Title: **STAGE 1&2 ROAD SAFETY AUDIT**  
**For;**  
**Old Kilcullen Heritage Trail**

Report reference: **2134R01**

VERSION: **FINAL (26-3-2024)**

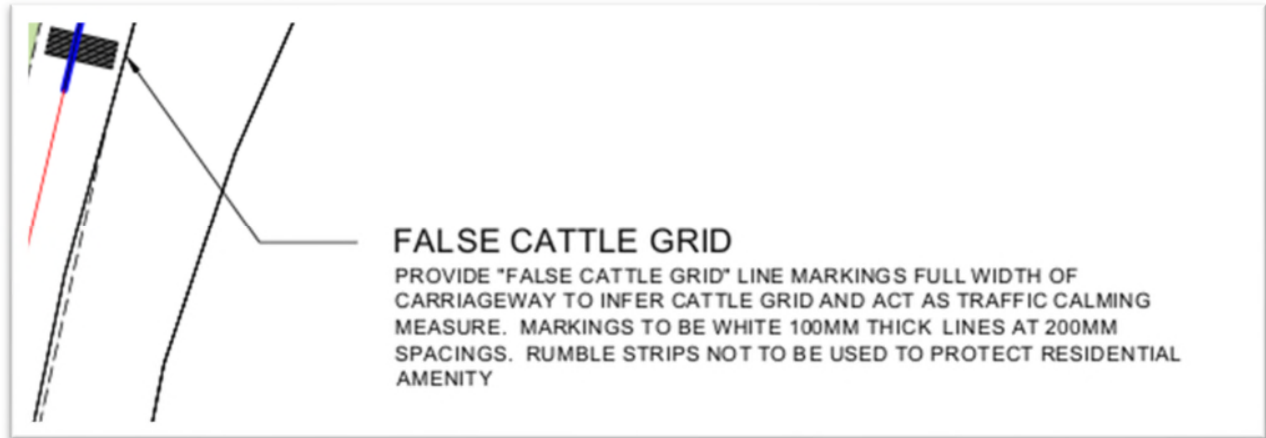
The R448 is a busy regional road and has a dedicated left turning lane into the L6080. It is also a very wide junction. This will lead to high turning speeds into the L6080 which could lead to collisions with pedestrians on the carriageway adjacent to the memorial. The Audit Team feel that the proposed gateway treatment and signage will reduce speed but from a high starting point and possibly not sufficiently.

It is recommended that the left turn lane be removed and that the junction mouth be narrowed.

Throughout the scheme, lighting.

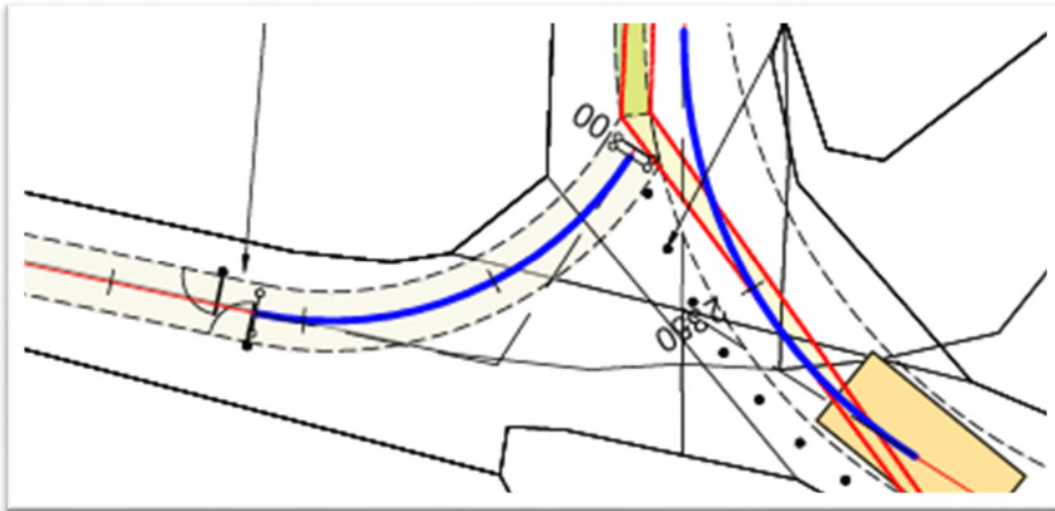
The scheme is to promote walking and cycling on the carriageway. There is some public lighting along the route but it is inconsistent. A lack of consistent lighting could lead to dark spots where drivers may not see pedestrians during the hours of darkness if they are wearing dark clothes. Given that the current operation speed is 75km/hr and through a reduction is expected a collision with a pedestrian at 50km/hr has an approximate 60% risk of being fatal. The likelihood of a collision will increase when the road is being promoted as a shared space.

It is recommended that continuous consistent lighting be provided.

Drawing 01/094 Rev 0, Walking track.

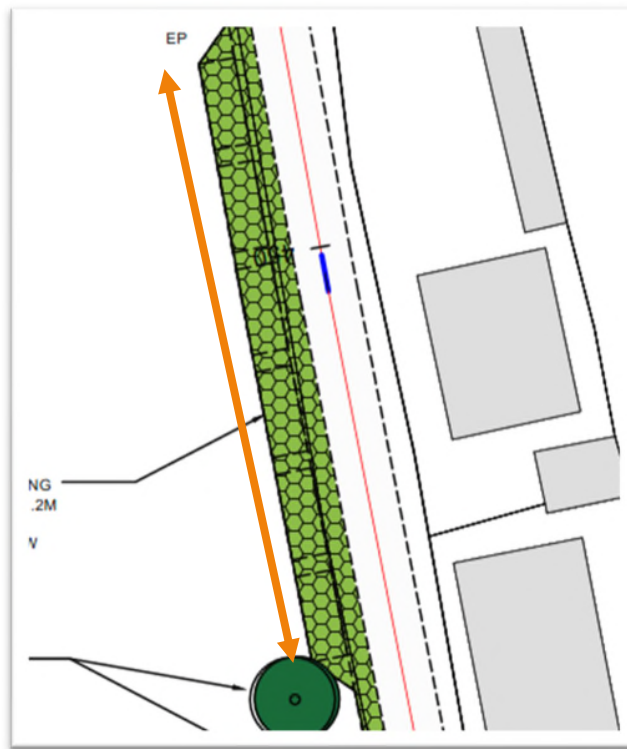
Drivers will need to be advised that they cannot turn into the walking track. The gates may not be obvious from the L6080 due to the layout/geometry of the track.

It is recommended that 'no entry' signage or similar be provided at a location easily seen by drivers on the L6080.

Drawing 01/02 Rev 0, Parallel parking spaces.

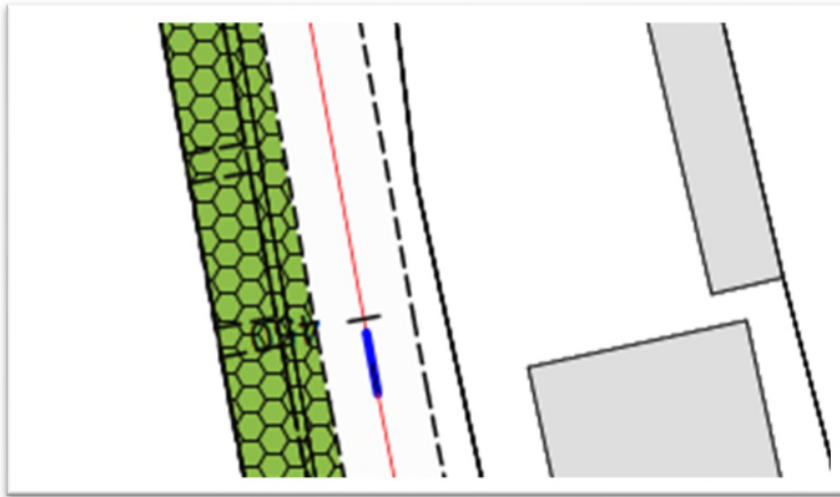
The parallel parking spaces have a grassed area to the rear. There is a risk that vehicle occupants when they exit their vehicles will slip and fall in wet or icy conditions.

It is recommended that the reinforced grassed area be extended to the rear of the spaces and that a connection be provided to the carriageway.
